Immingham Eastern Ro-Ro Terminal

## **Deadline 6 Appendix**

**Associated Petroleum Terminals (Immingham) Limited and  
Humber Oil Terminals Trustee Limited**

**RESPONSE TO CONSULTATION ON PROPOSED CHANGES TO THE APPLICATION**

Figure 2 – Proposed realignment of the Approach Jetty and related works

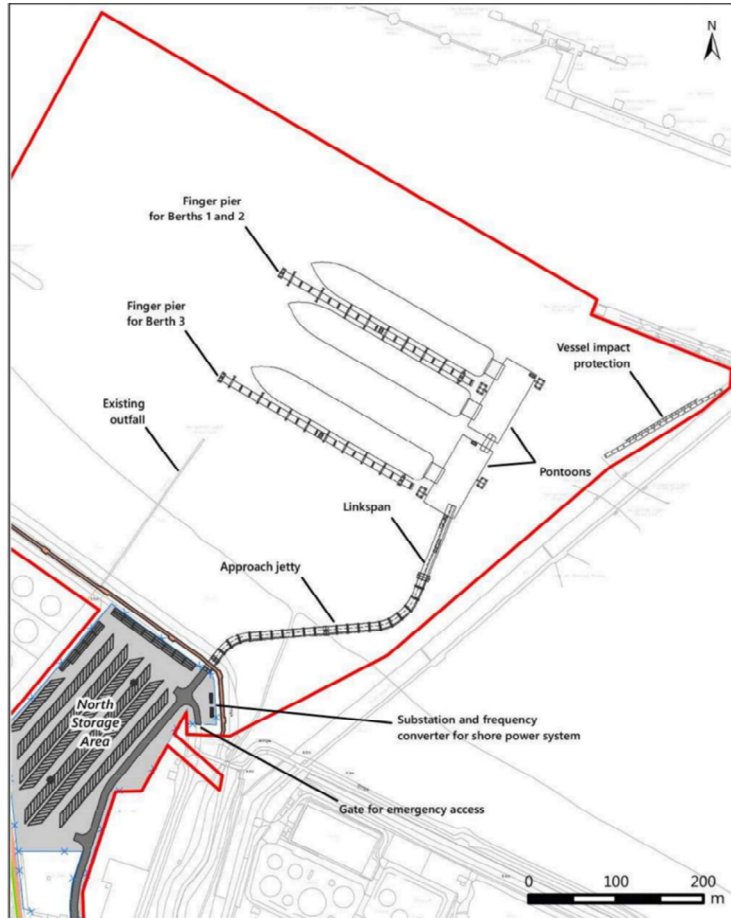
- 2.1 At para. 2.13 of the change request **Restraint dolphins** are included, which the Applicant ABP notes include up to two additional restraint dolphins for each of the landing pontoons to improve stability. These are identified in "*Figure 2 – Proposed realignment of the Approach Jetty and related works*" – see figure above with restraint dolphins identified by orange pecked line. At Section 3.1 of the Change Request, which describes the "Rationale and Need for the Changes", restraint dolphins are conspicuous by their absence and as such no details are provided by the Applicant justifying the need for restraint dolphins.

- 2.3 The IOT Operators welcome the inclusion of restraint dolphins in the change request, and the implicit acceptance that the IOT Operators sNRA findings in this regard is correct.

- 2.4 However, the IOT Operators' are not able to understand:
- (a) The calculations which have informed the design details which are being used in the Applicant's change request; or

(b) Where any updated NRA has been carried out to understand the effectiveness of the proposed restraint dolphins to mitigate allision risk.

- 2.5 In its change request the Applicant does not explain the purpose of the additional restraint dolphins. The IOT Operators have repeatedly requested information and detail (from first engagement on the project in Feb 2022 through to Examination Deadline 5) on the design of the IERRT and its ability to withstand the allision of an errant IERRT vessel. Most recently, the IOT Operators have requested such detail during the three design workshops. During these design meetings, Ben Hodgkins (ABP Group Head of Projects) noted that details would be provided on the ability of the IERRT infrastructure to withstand an errant vessel in due course, however no details have yet been provided.

- 2.6 Without the justification behind the design basis for the change to include additional restraint dolphins to the pontoons, the IOT Operators assume that the inclusion of the restraint dolphins, if constructed, would be to provide additional “implicit” impact protection to the IERRT structure, and as such provide additional protection to the IOT Trunkway. Therefore, IOT Operators require both the engineering design and impact loading parameters to be provided showing what the effect the restraint dolphins have on mitigating allision of an IERRT vessel with the IOT Trunkway, and separately mitigate the risk of the pontoons from becoming detached such that they may collide with the IOT Trunkway. It is also noted that para. 2.210 of Appendix 1 notes that the pile size of the restraint dolphins is proposed to be increased from 1,422mm to 1,520mm.

- 2.7 Further, as this is an additional risk control measure (not included in the ES or NRA), then an update to the Applicant’s NRA should be undertaken to confirm the effectiveness and justification for this additional risk control measure and subsequently issued for consultation. It is imperative that the IOT Operators are provided with this information in order to make an informed judgement on the effectiveness of the restraint dolphins as a risk control measure.

- 2.8 In the event the Applicant accepts that these restraint dolphins are necessary, it is critical that controls are imposed on the dDCO which require their delivery prior to commissioning of the first berth. The Applicant notes in this regard that in **[AS-020]** the Applicant has accepted that protective provisions “substantially in the form” included in the IOT Operators’ submissions REP1-039 would be included as part of any change request. The Applicant has provided a dDCO which includes such provisions, and should confirm that appropriate protective provisions will be included in the dDCO.

- 2.9 At para. 2.14 the Applicant notes that two additional piles to support mooring bollards have been added to improve mooring performance. The IOT Operators note that, as with the restraint dolphins, no details are provided by the Applicant to justify the inclusion of these additional piles. To date, no details other

- 2.10 The IOT Operators therefore seek that the Applicant provides, or is required to provide, evidence to support this change and, if it relates to navigation safety, then a commensurate update in the Applicant's NRA to address the change.

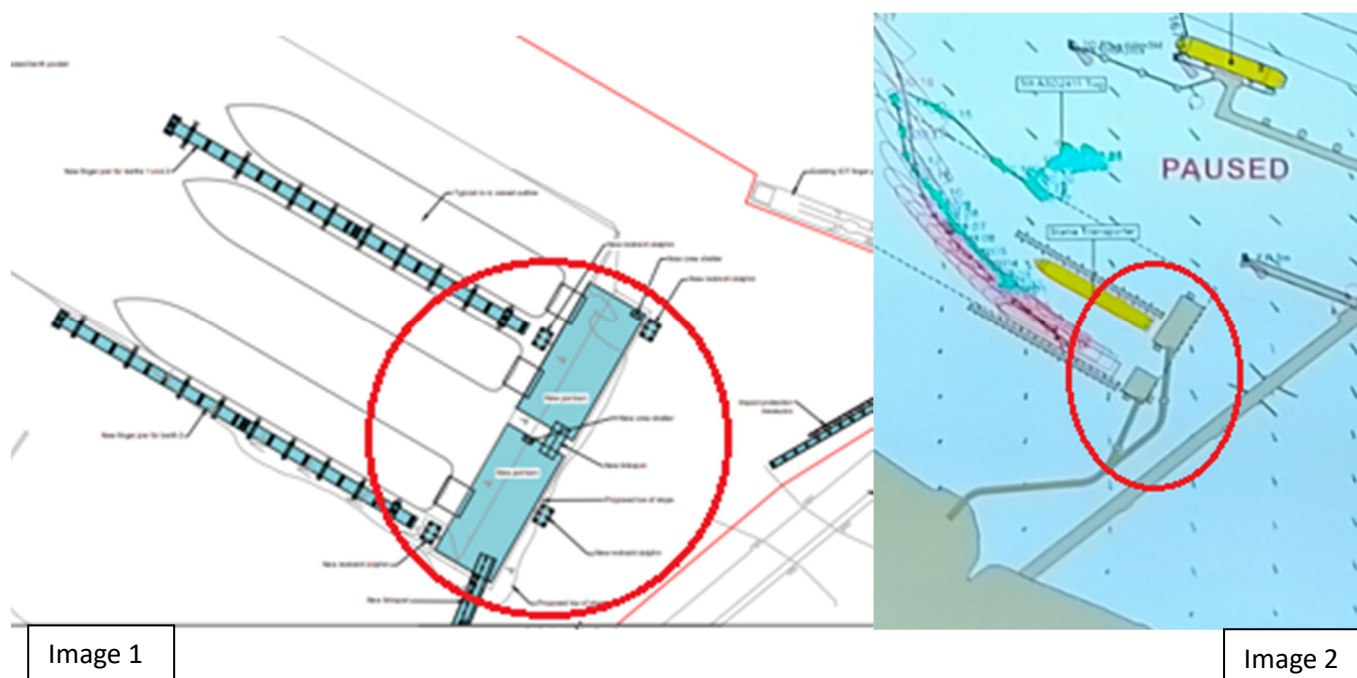
14. A discussion was held between APT / Nash and HRW on the interpretation of ‘gusting’. HRW software can add a ‘variance’ around the mean wind but if gusting is required then gusts have to be applied manually by the simulator operator. APT / Nash pointed out that if gusting is only applied to an extent above the mean wind rather than a combination of above and below the mean, then this would effectively raise the mean to a higher level, therefore the only way to replicate upward and downward variations around the mean would be to use the ‘variance’ feature, although this is unlikely to replicate the level and duration of peaks and troughs actually experienced on the river at Immingham. The routine variance applied by HRW (and used in all IERRT simulations to date) is +/- 2.5 knots around the mean wind. APT / Nash pointed out that, whilst this level of variance might be reasonably representative for low wind speeds, the variance generally experienced during higher winds, especially those associated with low pressure systems, is far higher. HRW stated that the variance settings can be made higher if required.
